Substitution of tension roller 55560 by 55515

Technical Info no. 1966

Renault: Espace, Fuego, Master,
Trafic, 18, 20, 21, 25, 30
Jeep: Cherokee, Comanche

J8S 2.1 D, 2.1 TD

Pic. 1: Replaced and new tension roller design

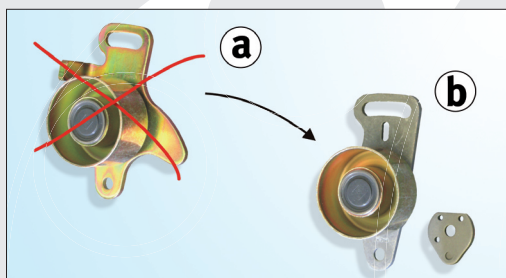
The tension roller no. 55560 is no longer available and has been substituted by part no. 55515 (see Pic. 1). The tension roller 55515 consists of two components:

- tension roller with carrier plate
- spacer plate

- a) Tension roller 55560
b) Tension roller 55515

Pic. 2: Belt drive layout

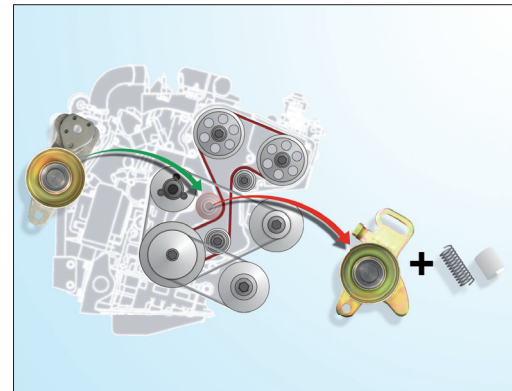
1. Bring the engine into position as specified by the manufacturer.
2. Remove the tension roller to be replaced (spring and sleeve can be disposed of).
3. Mount the new tension roller (you may employ the used part's bolts).
4. Tension the toothed belt using the recommended tools.
5. Torque down the fastening screws according to the manufacturers specifications.
6. Perform two rotating cycles of the crankshaft by hand; rotate it in the engine's running direction.
7. Use an appropriate tool to check the belt tension and re-adjust if necessary (repeat steps 4 to 6).
